ADDENDUM NO. 1

RE: Mill Creek Bridge (Br. NO. 1501) Denver Street - Marion Road SE Bridge Replacement, Grading, Paving and Drainage

Please note the following revisions to the Plans:

SCALE: [Scale]
SHEET: 2

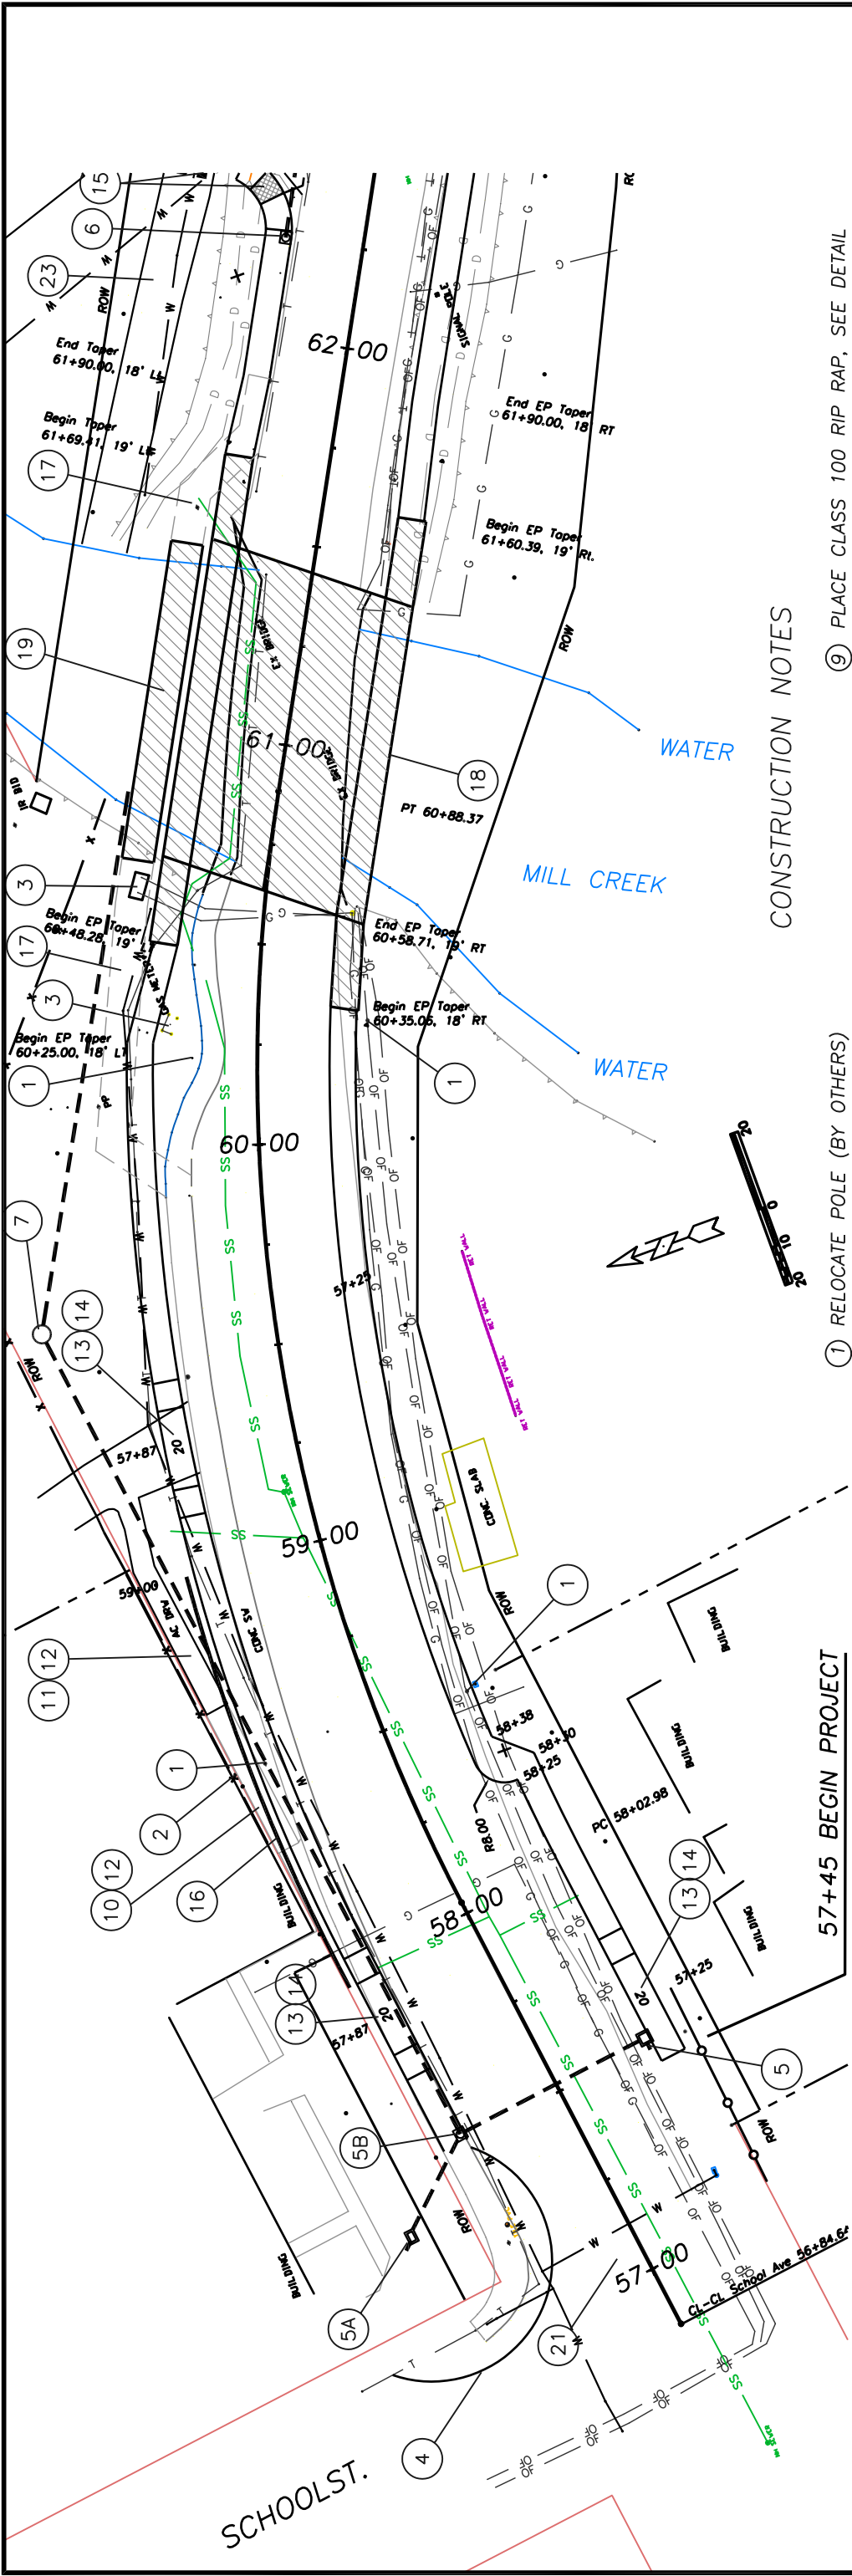
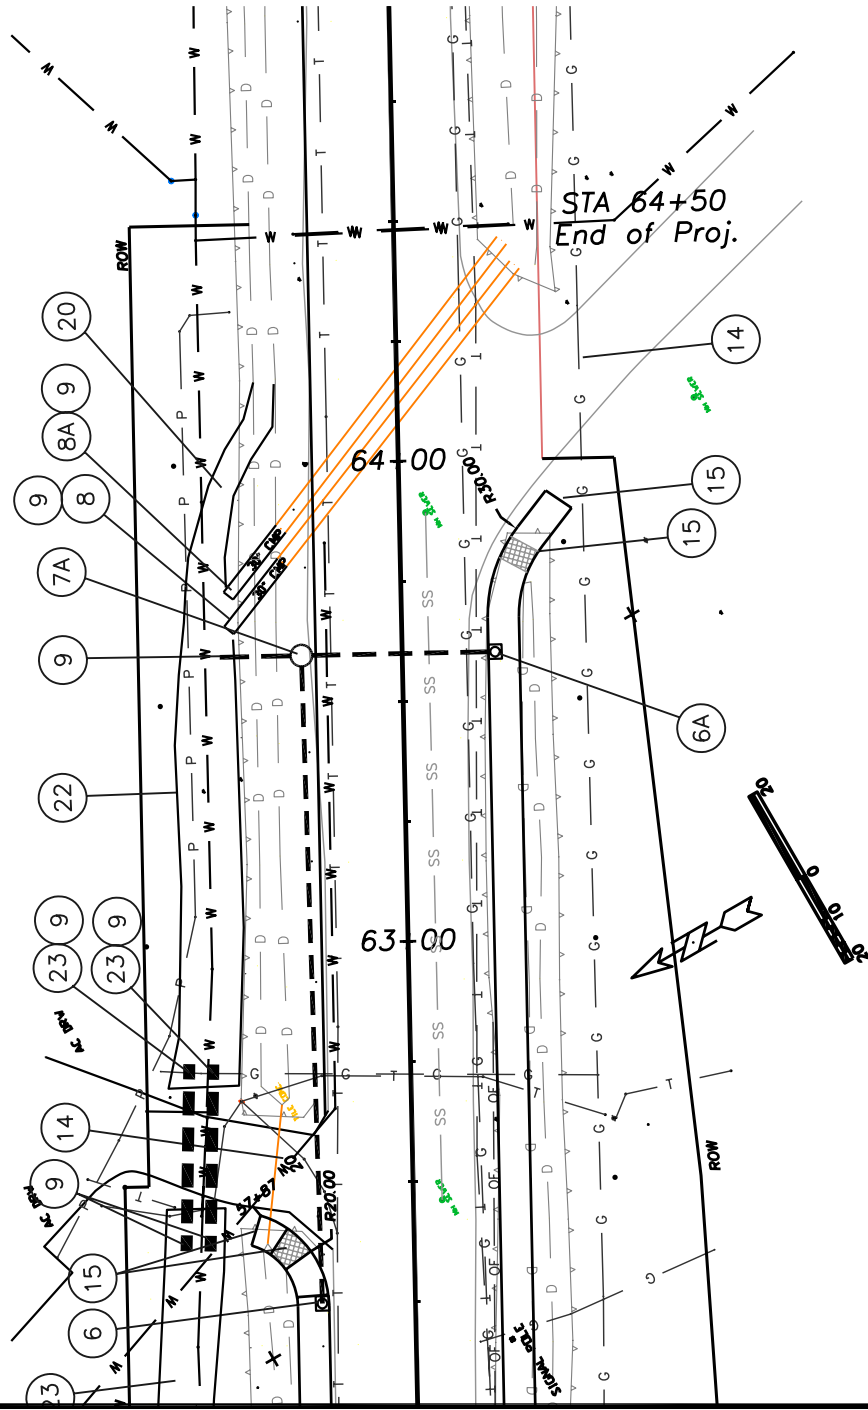
Replace sheets 2, 2B, 3, 3A and 3B with the enclosed sheets. Changes are clouded and include correcting omissions on the pipe profile and increasing the depth of the pipe run on sheet 3A.
